Subject: Notice of Deficiency: Bittinger #3
UIC Class II-D Well (Commercial) Permit Application
Columbus Township, Warren County, Pennsylvania

In response to the USEPA Region III comment letter dated June 2, 2015 on the subject UIC Class II-D Well permit application, this letter summarizes each comment and Bear Lake Properties, LLC's (Bear Lake Properties') response.

MONITORING WELL NETWORK FOR
EXISTING AND PROPOSED INJECTION WELLS
BEAR LAKE PROPERTIES, LLC
WARREN COUNTY, PENNSYLVANIA

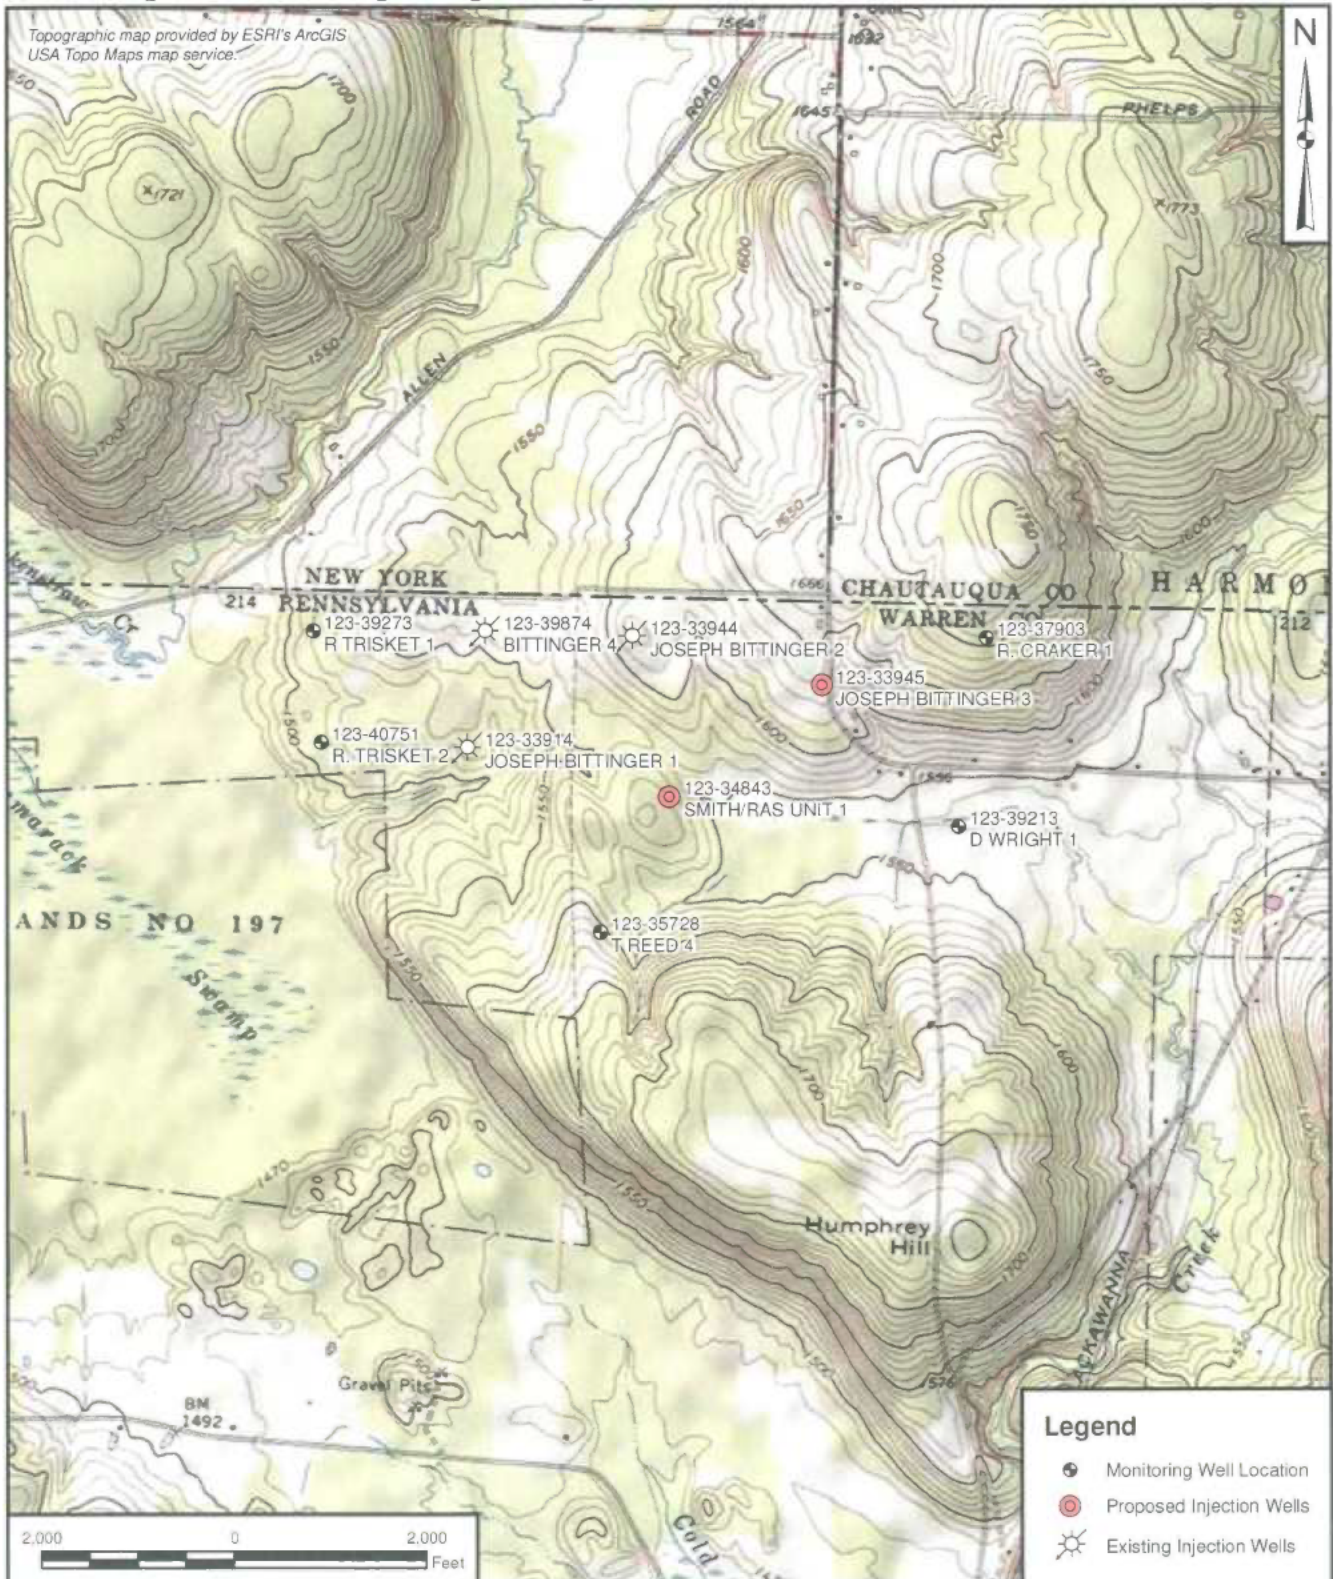
4. **Comment:** Corrective Action Plan – R. Craker #1 and D. Wright #1 are listed as monitoring wells to be used for monitoring Bittinger #3. As requested in the Smith-Ras 1 Notice of Deficiency, describe in detail the monitoring network that will be used to monitor all five injection wells.

Response: The following strategically located wells have been selected to monitor the three existing and two proposed injection wells:

Monitoring Well	Producing Interval
R. Trisket #1	Medina-Whirlpool
R. Trisket #2	Medina-Whirlpool
T. Reed #4	Medina-Whirlpool
D. Wright #1	Medina-Whirlpool
R. Craker #1	Medina-Whirlpool

A map showing the location of the monitoring wells is included as Attachment #2.

Figure 1

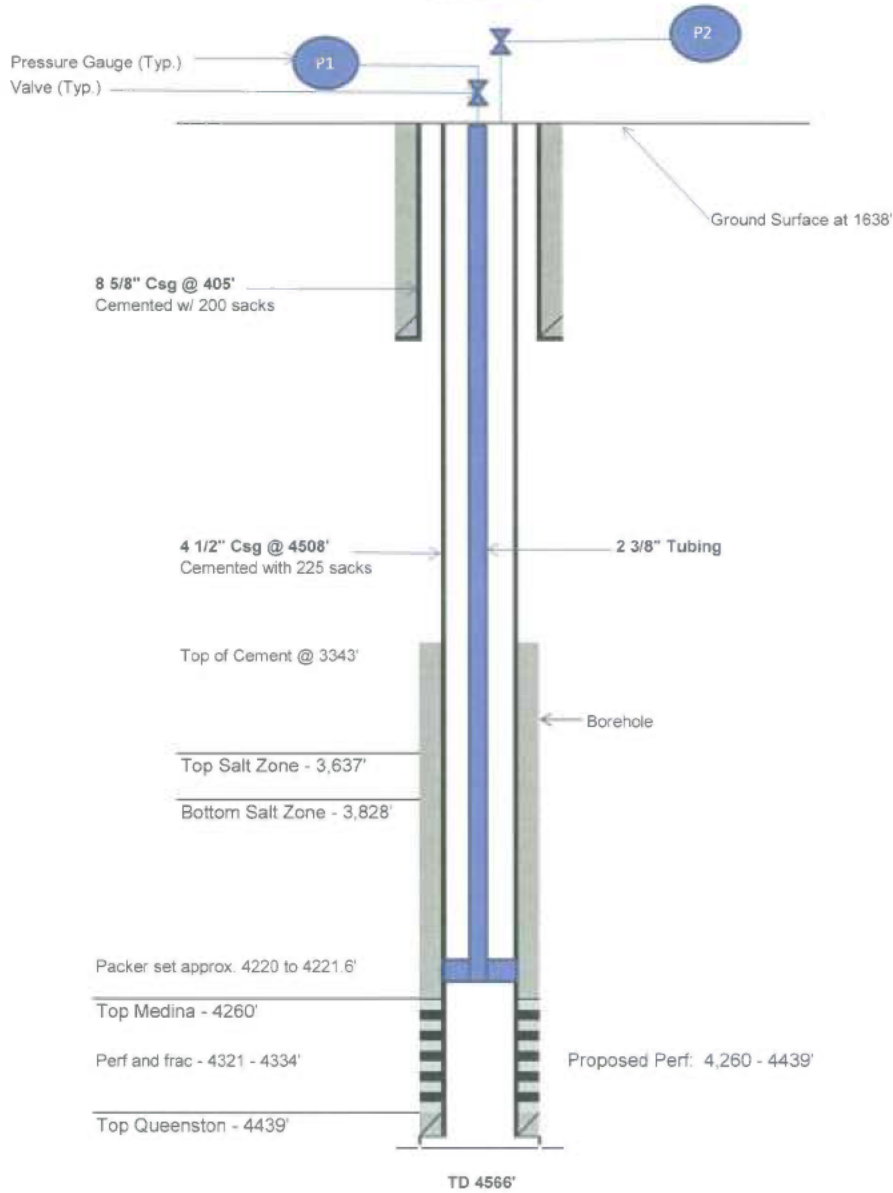
6. **Comment:** Geologic Data/Well Construction – The well completion record for Bittering 3 lists perforation from a depth of 4321' to 4334', which penetrates the Grimsby layer. The well construction diagram, however, lists perf and frac from 4,260'-4,439' which penetrates the Grimsby, Power Glen, and Whirlpool layers as described in the permit application. This is also a difference in injection interval of 13' versus 179'. Please account for the discrepancy in these records and confirm the correct injection interval.

16. **Comment:** Well Construction – The total depth in figure 1 diagram of the well is 4566 feet. Was the well plugged back to the injection interval proposed in the application?

Response: The well completion record for the Bittering #3 shows the intervals and depths perforated as part of the original well completion. Bear Lake Properties intends to perforate the entire Medina-Whirlpool interval to maximize injection potential. The proposed injection interval for the well was shown on the well construction diagram. The well construction diagram has been revised to reference both the original perforated intervals as well as the proposed perforated interval for the injection well (Attachment #3).

Response: The state completion report lists the logged TD as 4566'. The state completion report lists the total 4-1/2" casing depth of 4508 and the perforation interval as 4321-4334'. The proposed perforation interval (i.e., injection interval) is 4260-4439'. Any space below the perforated interval down to the casing shoe is likely filled with fluid and frac sand.

Injection Facility Layout Schematic

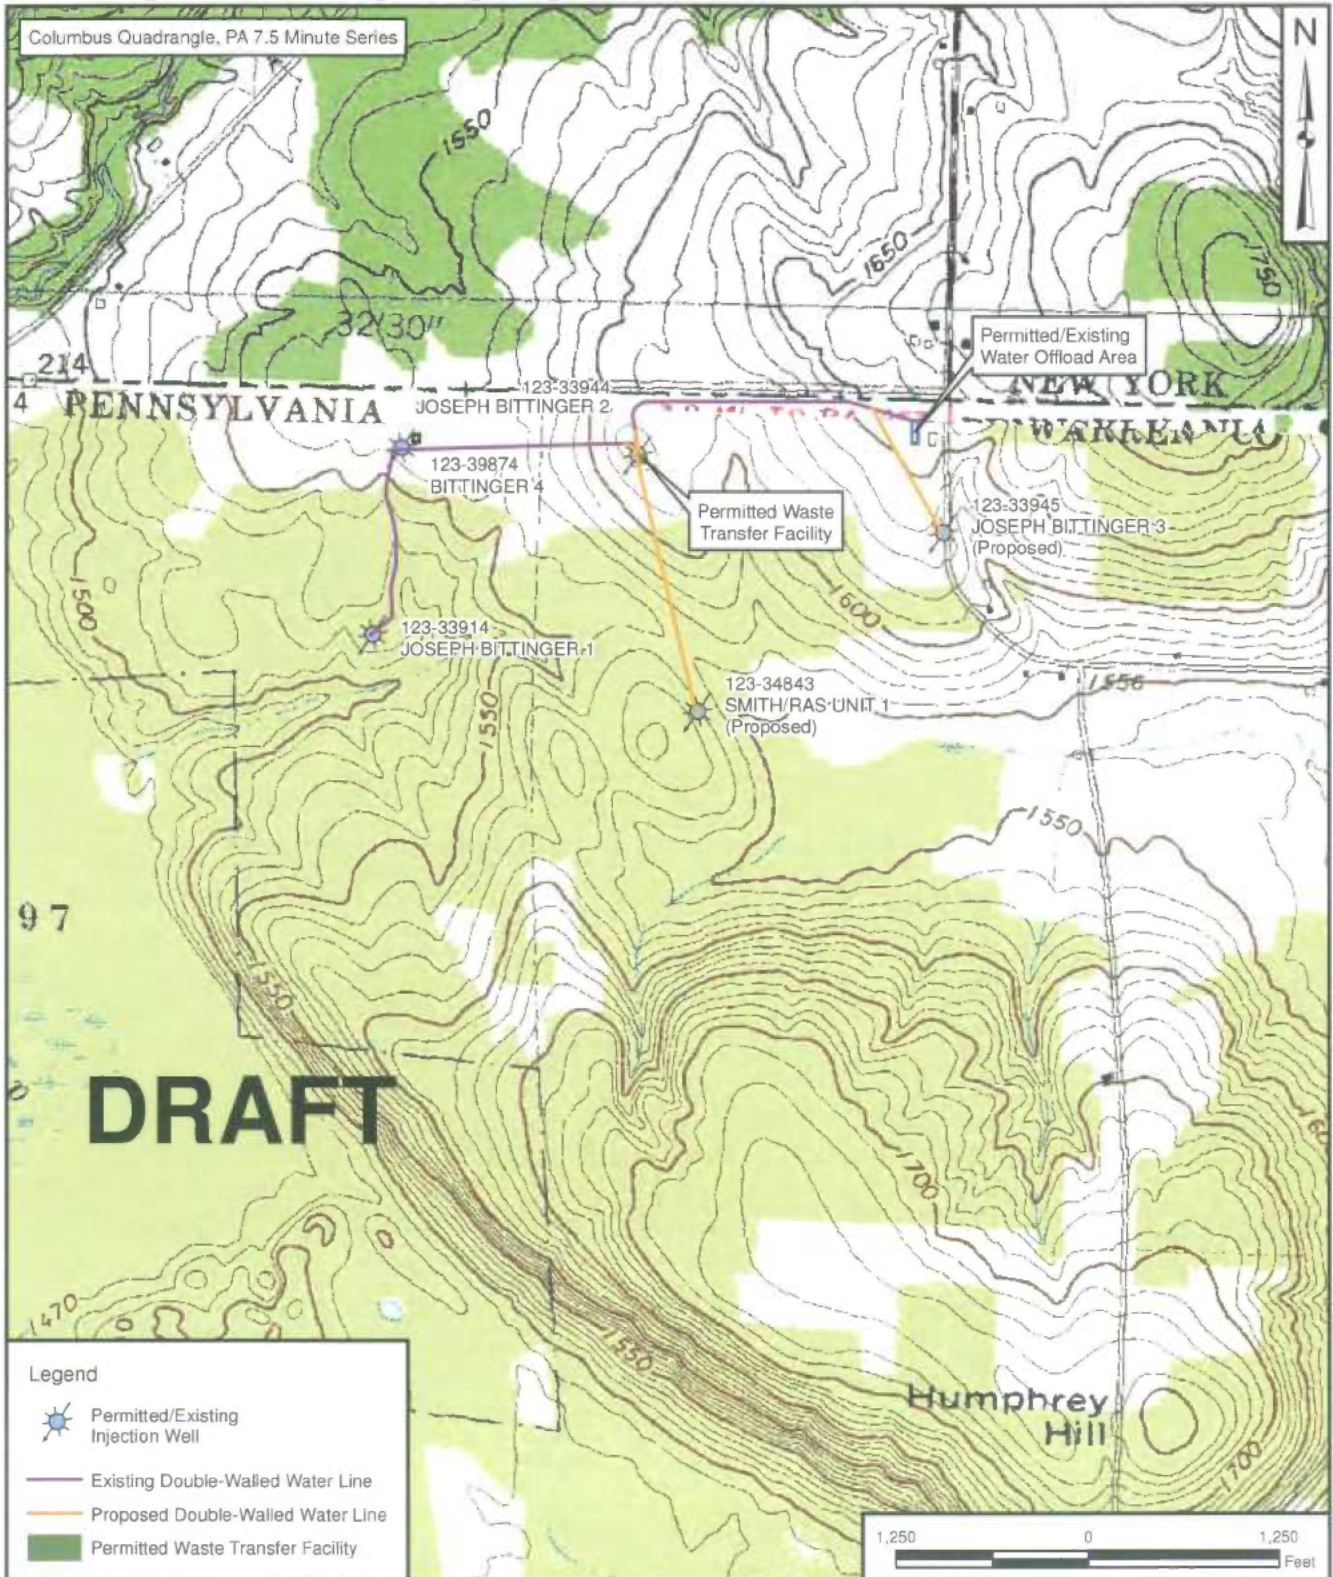
14. **Comment:** Operating Data – The "Injection Facility Layout" schematic shows currently hooked up injection wells, but does not show proposed Smith-Ras 1 or Bittering 3 connections. Please show how these will be incorporated into the existing plan.

Response: Attachment #6 is the revised Injection Facility Layout schematic shows the proposed connections for Smith-Ras #1 and Bittering #3 wells.

FINAL PLUGGED WELL DRAWING

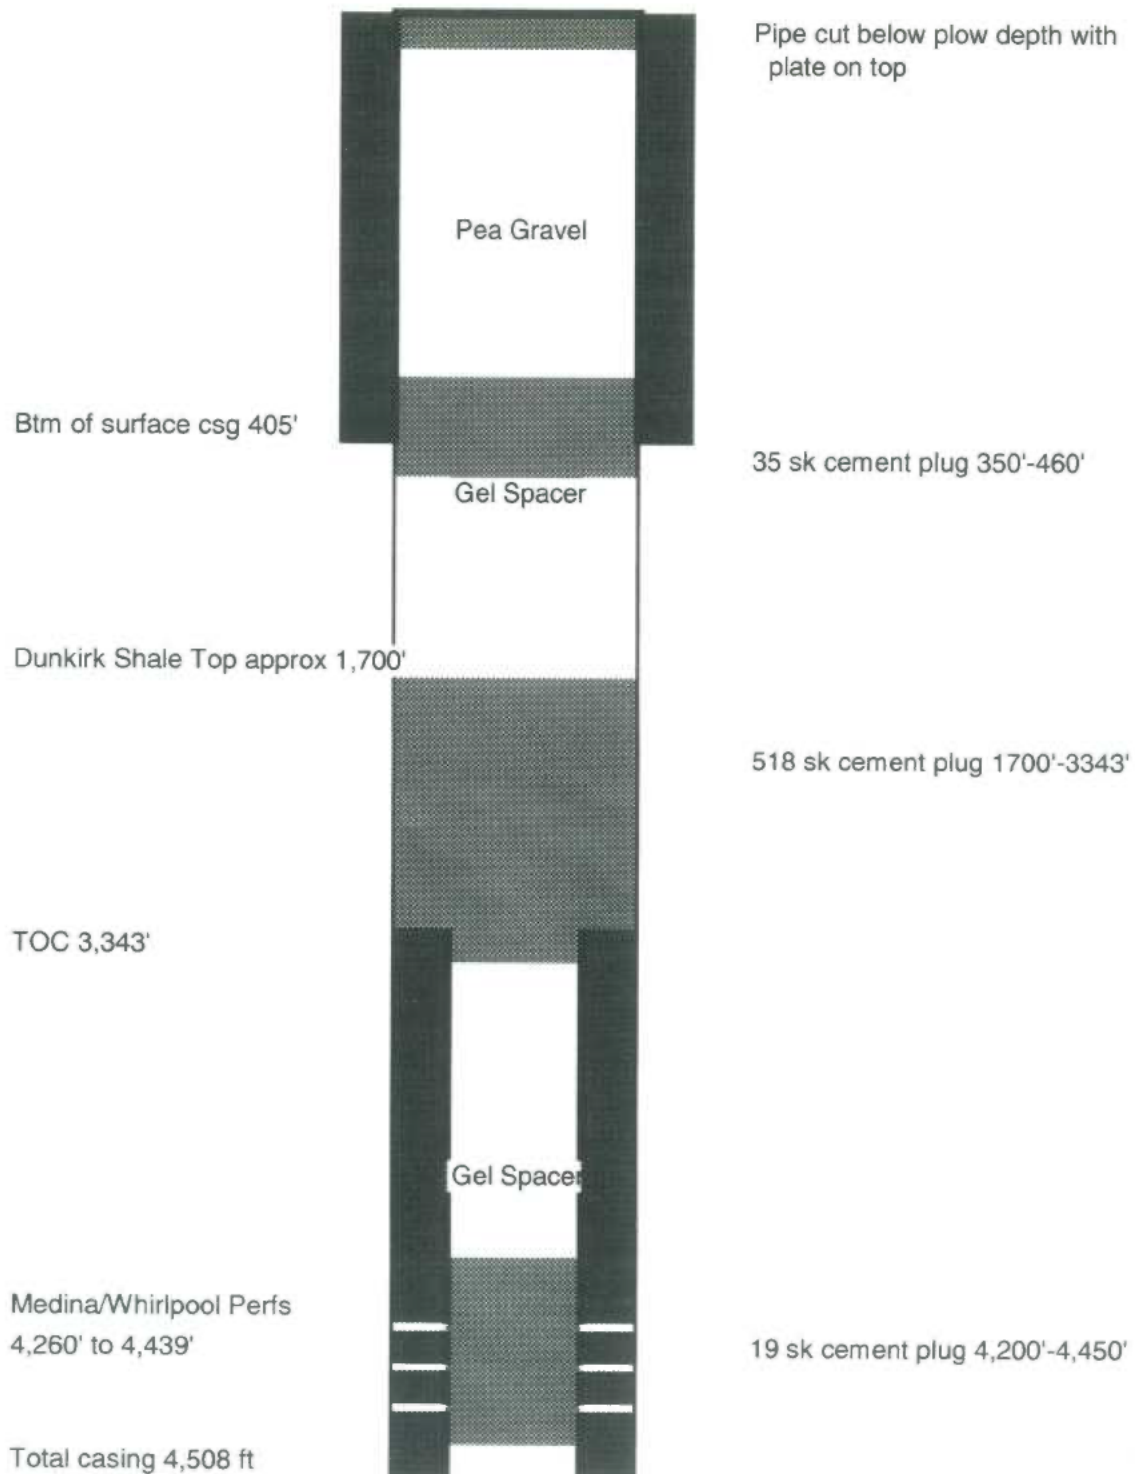
17. **Comment:** Plugging – The plugging diagram shows the surface plug below the casing seat. EPA requires at least 50 feet of cement above and 50 feet of cement below the surface casing seat. Please update the plugging and abandonment plan and cost estimate for plugging with the new cemented interval.

18. **Comment:** Plugging – As stated in item 6, perf and frac depths do not match well completion report. After providing confirmation of discrepancy adjust injection zone plug depth accordingly so that plug is 50-100 feet above the top of the injection zone.

Response: The plugging plan included in Attachment #7 has been updated to reflect the 50 feet above and below casing seat.

Response: The attached plugging plan and "Final Plugged Well Drawing" (Attachment #7) have been updated and the plug top has been adjusted to reflect the shallowest proposed perforation of 4260' which will be at the top of the Medina-Whirlpool interval. The existing perforated interval (4321 - 4334') and proposed perforated interval (4,260 – 4439') for the injection well are shown on the previously referenced Well Construction Diagram (Attachment #3).
